Access Compliance Report

Public Rights-of-Way

(Curb Ramps)

Intersection ID: 27432	Main Street: BALLANTYNE COMMONS PY	Cross Street: DURANT BV	Location: NW
ADA ID: A7359C14412B	Ramp Type: Perp	Initial Pass/Fail: Fail	Overall Compliance: No
Codes/Mitigation Info/Possible Solution		Field Measurements/Component Compliance	
Severity Score: 13.75

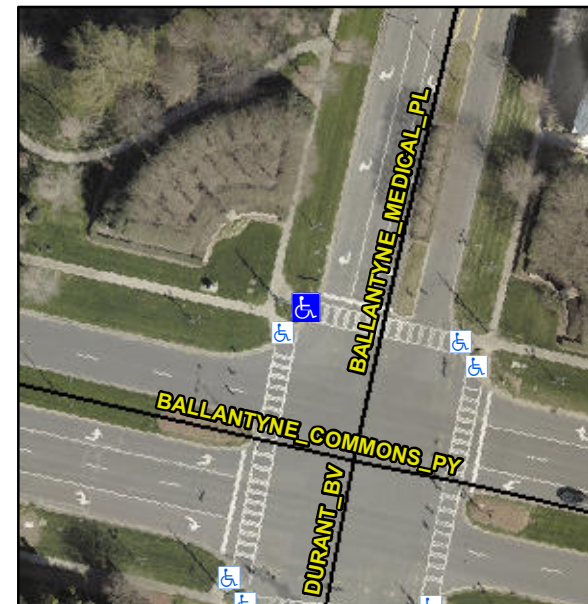
Not Found, R304.2.2, R304.5.3

Compliance	Description	Data	Compliance	Description	Data
N/A	Ramp Length (in)	86.0	No	Ramp Slope (%)	8.4
Yes	Ramp Width (in)	48.0	No	Ramp XSlope (%)	3.3
N/A	Flare Type LT	N/A	N/A	Flare Type RT	N/A
N/A	Flare Slope LT (%)	N/A	N/A	Flare Slope RT (%)	N/A
N/A	Flare Traversable LT?	N/A	N/A	Flare Traversable RT?	N/A
N/A	Landing Length (in)	N/A	N/A	DWS Provided?	N/A
N/A	Landing Width (in)	N/A	N/A	DWS Contrast?	N/A
N/A	Landing Slope (%)	N/A	N/A	DWS Length (in)	N/A
N/A	Landing X Slope (%)	N/A	N/A	DWS Full Width?	N/A
N/A	Landing Curb? (Y/N)	N/A	N/A	DWS Offset (in)	N/A
N/A	Shared Landing?	N/A			
N/A	Gutter Ponding?	N/A	N/A	Gutter Slope (%)	N/A
N/A	Gutter Lip Ht (in)	N/A	N/A	Gutter X Slope (%)	N/A
N/A	Painted X Walk1?	Yes	N/A	Painted X Walk2?	N/A
	X Walk 1 Direction	To SE		X Walk 2 Direction	N/A
N/A	X Walk 1 Width (in)	124.5	N/A	X Walk 2 Width (in)	N/A
	X Walk 1 Slope (%)	0.8		X Walk 2 Slope (%)	N/A
	X Walk 1 X Slope (%)	1.5		X Walk 2 X Slope (%)	N/A

Remove & Replace Entire Ramp.
